## Lake Oroville Spillways Emergency Recovery

# Board of Consultants Memorandum No. 13 – October 20, 2017

## Board of Consultants Memorandum

SUBJECT: Memorandum No. 13

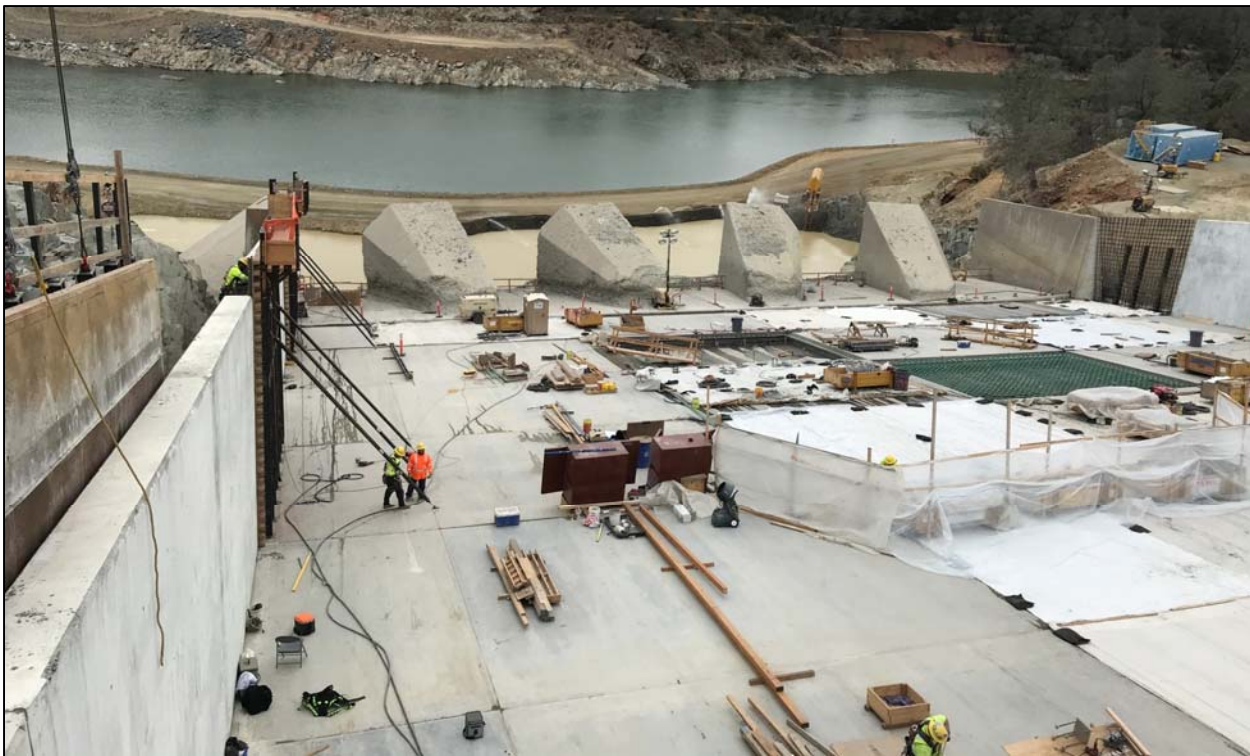
The aforementioned work observed by the BOC appeared to be in conformance with the specifications and of high quality. Select photographs of observed work are provided in Figures 2, 3, 4 and 5.
